# UNITED STATES PATENT AND TRADEMARK OFFICE

<b>Office Action Summary</b>	<b>Application No.</b> 10/597,927	<b>Applicant(s)</b> THIEWES ET AL.	
	<b>Examiner</b> Carl D. Price	<b>Art Unit</b> 3749

**DETAILED ACTION****Response to Arguments**

Fig. 1

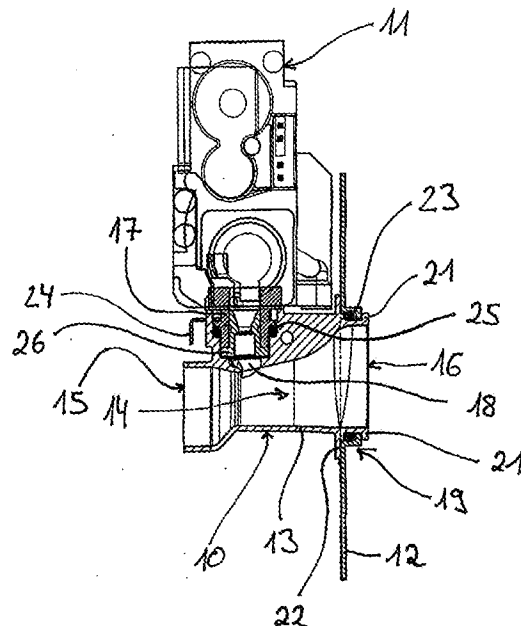
As seen from applicant's own specification and associated drawing figures the meaning of the term "housing" might at least be defined as the outer surface of the body referenced by reference character "13" (Figure 1), and at most to the physical material or the body of material making up the member generally associated by reference character "13". Similarly, the meaning of the term "venturi" is defined by a contoured passageway referenced by numeral "14" (Figure 1) and located within or passing through the physical material or the body of material making up the member generally associated by reference character "13". In this regard, applicant has described or defined the terms "housing" and "venturi" in a manner no more specific or detailed than the mere mention of each of these terms in the specification and only a direct correlation of the terms with the structure referenced by reference numerals "13" and "14", respectively.

Turning now to applicant's claims, consistent with the scope of the invention described in the specification applicant merely uses the terms "housing" and "venturi" to only broadly define certain aspects of the invention. Further in this regard, applicant is reminded that although the claims are interpreted in light of the specification, limitations from the specification are not read into the claims. See *In re Van Geuns*, 988 F.2d 1181, 26 USPQ2d 1057 (Fed. Cir. 1993). Therefore, with respect to the claims, a reasonable broad interpretation of the term "housing"

would be that of no more than a body of material having no particular shape or form. And, in regard to the claims, a reasonable broad interpretation of the term "venturi nozzle" would be no more than a contoured passage having a portion having a diameter defining a restriction there along. And, a reasonable broad interpretation of the recitation "the housing and the venturi nozzle are formed as a monolithic unit" would be that of a housing or a body of material having no particular shape or form integrally, or monolithically, formed with a contoured passage having a portion with a diameter defining a restriction there along, or Venturi. Or, stated differently, a monolithic material body or housing or no particular shape or form having a Venturi shaped nozzle or passage formed therein. Or, simple, a Venturi body.

Fig. 1

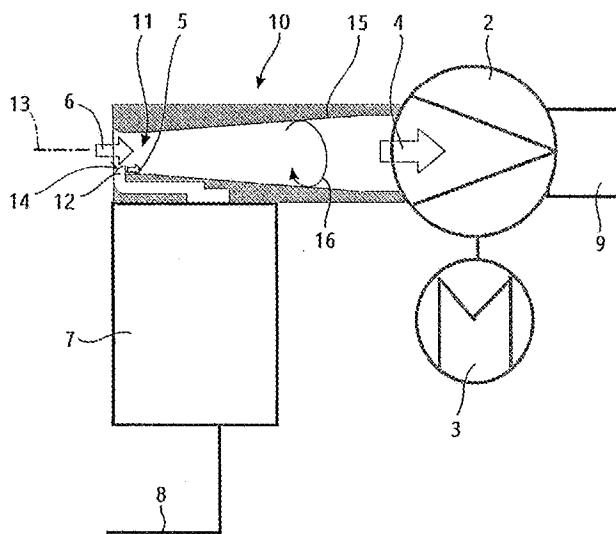
In view of the discussion herein above the examiner maintains that the claims define the invention by structure of such a broad scope that it is indeed met by **DE 197 33 768**, whether one relies on the relatively thick Venturi body of figure 1 or the relatively thin Venturi body shown in figure 2.

**FIG. 5**

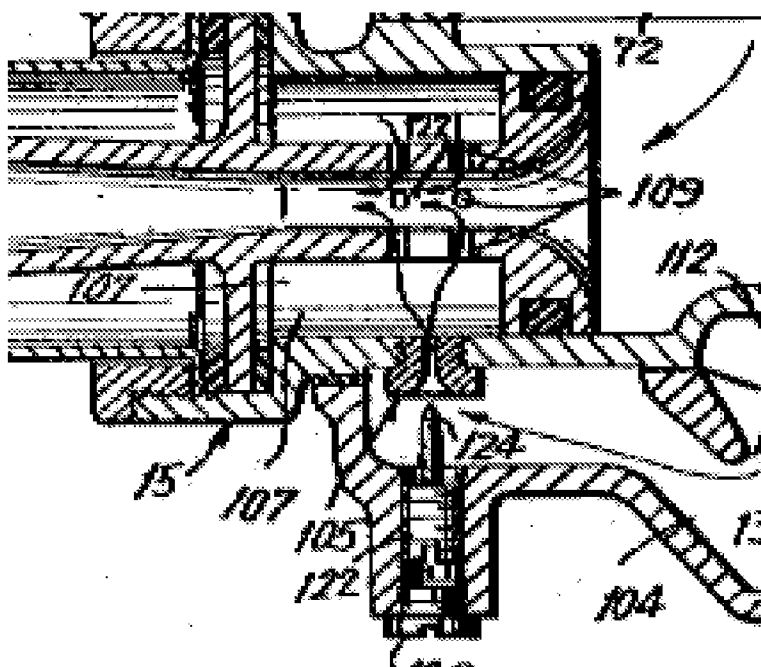
In response to applicant's argument(s) directed to the prior art previously relied on, and in response to the scope of the invention now set forth in the presently amended claims, the following examiner's action now additionally relies on the prior art reference of **DE 36 04 314 (Gruber)**. Most notably, with regard to the now claimed invention, **DE 36 04 314 (Gruber)** shows (Figure 5) and discloses a monolithic material body or housing (40, 48) having a Venturi shaped nozzle (44, 46) or passage formed therein.

**FIG. 5**

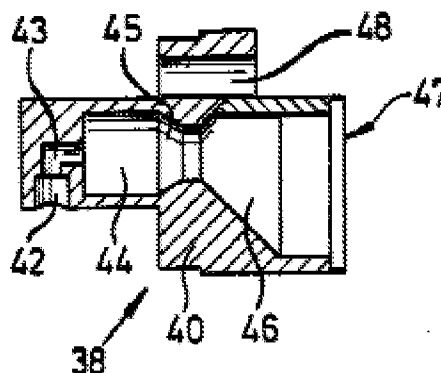
**DE 36 04 314 (Gruber)** shows (Figure 5) and discloses a monolithic material body or housing (40, 48) having a Venturi shaped nozzle (44, 46) or passage formed therein.
